Environmental Quality Commission

**STAFF REPORT****Environmental Quality Commission****Meeting Date:** 1/25/2017**Staff Report Number:** 17-002-EQC**Regular Business:****Issue: Determination on appeal of staff's denial of one Heritage Tree removal permit at 318 Pope St.****Recommendation**

Showing poor crotch formation with included bark.

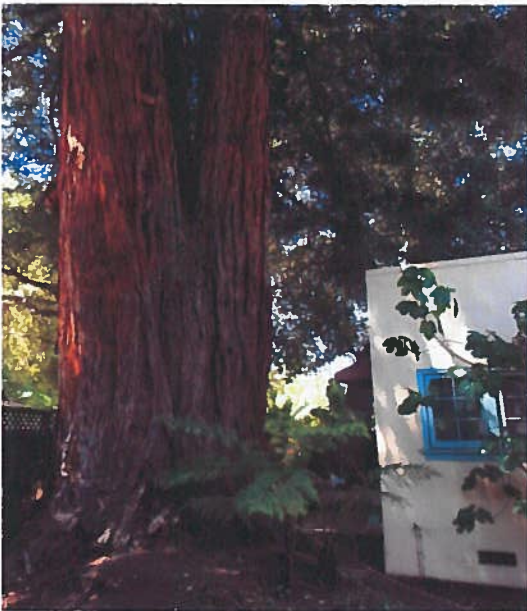
Mature redwood #5 has poor form and is the reason for its poor condition rating. This tree has a large trunk with a diameter of 95.7. The tree is codominant with 3 leaders starting at 15 feet. These 3 leaders all share apical dominance and have created poor crotches with included bark at 15 feet. Included bark forms in the junctions of codominant stems where there is a narrow angle union, meaning the junction looks like a "V" rather than a "U." As the tree grows the narrow union will essentially fill with bark and create a growing area of structural weakness in the tree. Even in young trees, when you notice a very narrow angle (creating a "V" at the junction of branches) it is likely that stress put on the either of the codominant stems can cause splitting, or even cause the stem to break off at the junction. As the 3 leaders grow they have the potential to push against each other often until the point of failure. Bulging is visible in these areas of included bark and often indicate a structural weakness. Also each leader is heavy to the direction away from the trunks and creates more stress to the poor crotch area at 15 feet. Because of this trees poor growth form and the trees target at a failure being the home or neighbors home, I am recommending this tree to be removed as it is a hazard to the property. The owner of the property would like to save the tree. Recommended mitigation measures are as followed:

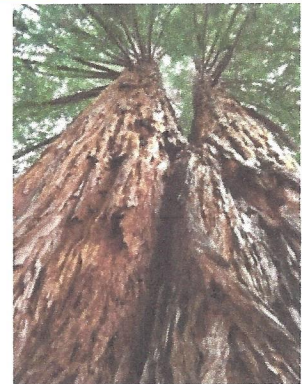
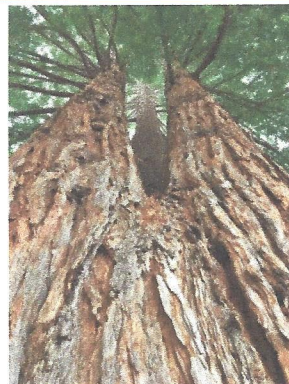
The main problem with this tree is the three main codominant leaders starting 15' above grade (see images to lower right). Codominant leaders, especially when they have included bark, are prone to splitting apart because they are not attached where they appear to be growing together (http://www.umass.edu/urbantree/factsheets/35codominantstems_rev1.html).

This tree has three main co-dominant leaders with included bark and the three leaders are not well attached to each other. In fact, each year the three main stems of this tree grow apart more and more. The union between these tree main stems is weak and highly prone to splitting apart. This is a well-known fact among trained Arborists. There is no disputing it. This isn't a matter of IF this tree will fail; it's a matter of WHEN.

The only acceptable mitigation for the risk represented by this tree is to remove the risk: tree removal.
